Redleaf - Redmond Place, Orange

Colliers International Engineering & Design (TTMC) Pty Ltd. has been engaged to undertake a Road Safety Audit (RSA) for proposed residential development located at Redmond Place, Orange NSW 2800. This RSA has been commissioned by Colliers International Engineering & Design (NSW) Pty Ltd as part of the design process of the project.

This report results from a Design Stage Road Safety Audit (RSA), which has been undertaken in accordance with the requirements of Austroads *Guide to Road Safety - Part 6 Road Safety Audit* (2022) (GRS Part 6). This audit has considered the various aspects of the road environment that may result in potential safety issues, generally in line with the elements/topics outlined in the Prompt Lists contained within Appendix H of the Austroads GRS Part 6.

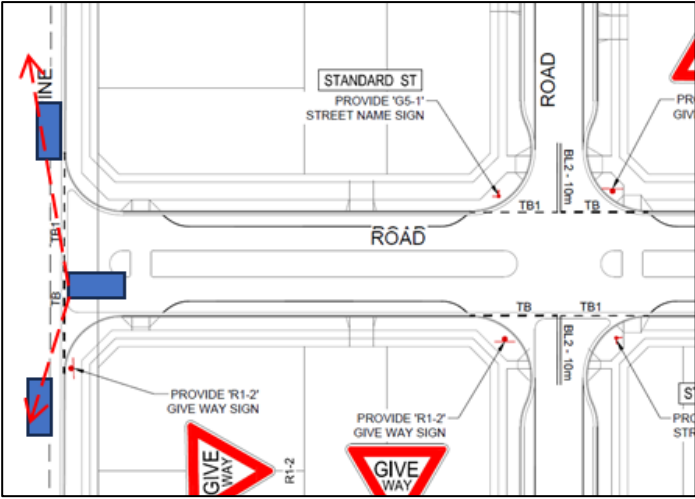
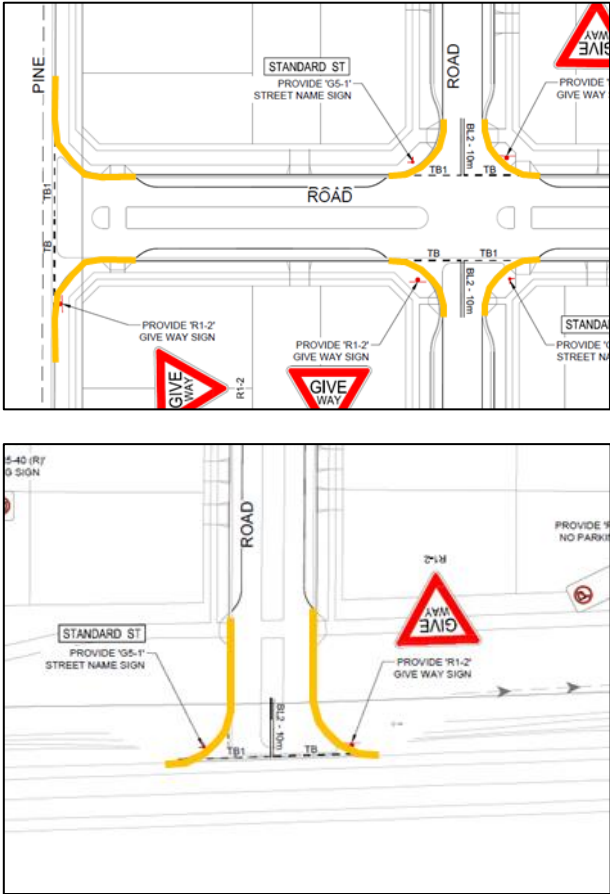
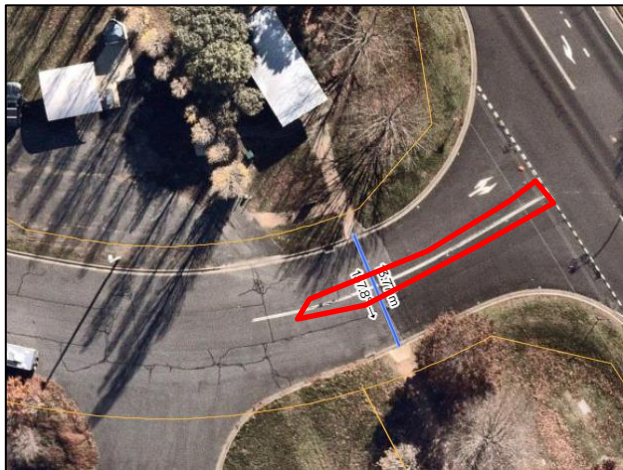
Item	Location	Audit Finding	Risk Level	Recommendation	Client Response	
					Accept Yes/No	Comments
1	Proposed Brabham Way southern site access	The Brabham Way / Southern Site Access intersection does not include turn lane treatments along the major road approach. Increased risk of rear end crashes of vehicles propped or slowing to turn into the new site access road (RUM Code 31, 32). Lack of protected lanes in the could lead to drivers accepting smaller gaps in order to get clear of through lane traffic, increasing potential of opposing vehicle crashes (RUM Code 21). 	<u>Severity:</u> Fatal <u>Likelihood:</u> Possible <u>Outcome:</u> Extreme (FSI)	Consider the inclusion of left and right turn lane treatments for entry movements from Brabham Way into the Southern Site Access. The inclusion of appropriate Auxiliary Left Turn Lane and Channelised Right Turn Lane treatment will help separate out turning movements and provide queue storage area clear of through vehicle movements.	Y	Additional turning lanes are provided in the amended civil plans

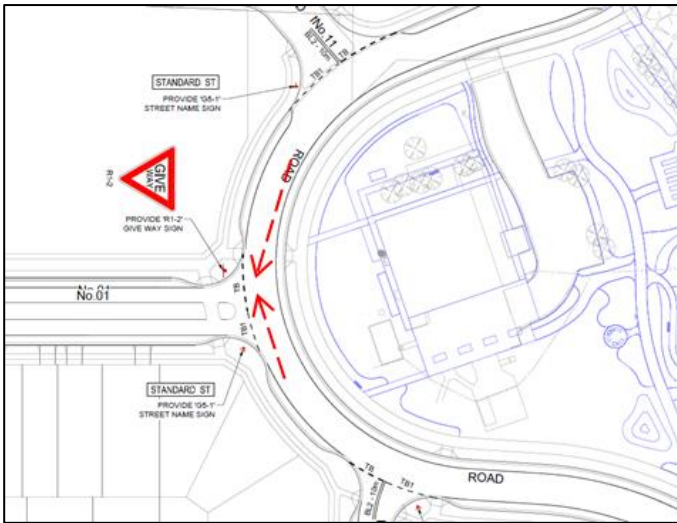
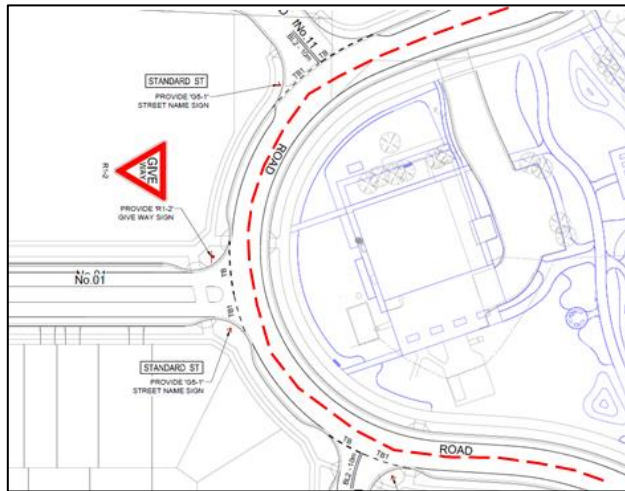
Item	Location	Audit Finding	Risk Level	Recommendation	Client Response	
					Accept Yes/No	Comments
2	Lone Pine Avenue near the southern cul-de-sac and Brabham Way / Lone Pine Avenue intersection.	The 90 degree turn at the southern end of Lone Pine Avenue is not well telegraphed by the road environment from the northern approach. There is also a Give Way sign for the northern approach, which does not seem to be required or appropriate for the road alignment. Risk of motorists misjudging the approaching bend and overrunning the corner, or crossing into the oncoming lane. 	<u>Severity:</u> Serious <u>Likelihood:</u> Possible <u>Outcome:</u> High (FSI)	Consider providing updated edge / continuity line marking treatment and signage (W2-16) on Lone Pine Avenue near the southern cul-de-sac and Brabham Way / Lone Pine Avenue intersection.  Consider reviewing and the updating signage and line marking near the cul-de-sac head to reprioritize the N/E road alignment.	y	Will be considered in the SWC stage

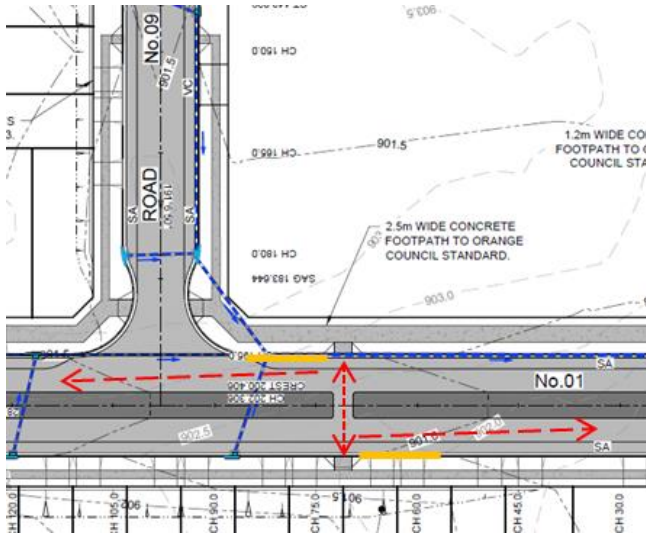
Item	Location	Audit Finding	Risk Level	Recommendation	Client Response	
					Accept Yes/No	Comments
3	Lone Pine Avenue Site Access Intersection	Lone Pine Avenue frontage does not include a centreline or lane edge line marking Increased risk of head on and intersection crashes due to motorists wandering within roadway or not positioning a vehicle on the roadway correctly. 	<u>Severity:</u> Serious <u>Likelihood:</u> Possible <u>Outcome:</u> High (FSI)	Consider including edge and centrelines along Lone Pine Avenue in proximity to the site access intersections to better delineate through lanes and parking shoulder areas. The perceived narrowing of the roadway should help manage speeds in proximity to the site access, potentially reducing crash severity and likelihood.	Y	Additional linemarking is provided in the amended civil plans

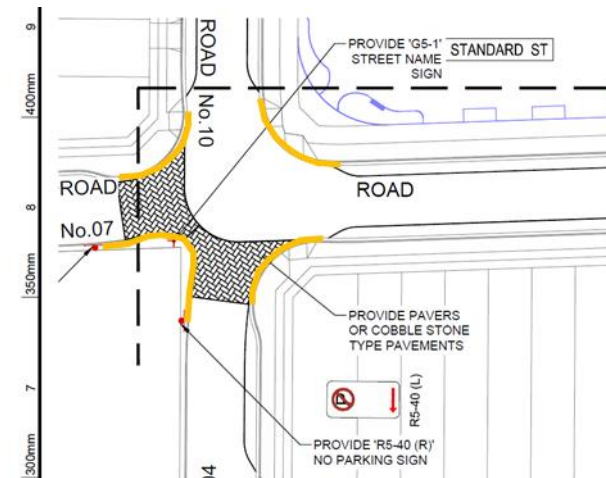
Item	Location	Audit Finding	Risk Level	Recommendation	Client Response	
					Accept Yes/No	Comments
6	Redmond Place (Road No.10)	The current Road No.10 does not show a centreline, combined with the curved entry road, there is a potential for vehicles to more readily cross the centreline, colliding with oncoming vehicles (RUM Code 20). 	<u>Severity:</u> Fatal <u>Likelihood:</u> Rare <u>Outcome:</u> High (FSI)	Consider including centreline along Road No.10 to help guide motorists along the curved roadway. 	y	Additional linemarking is provided in the amended civil plans
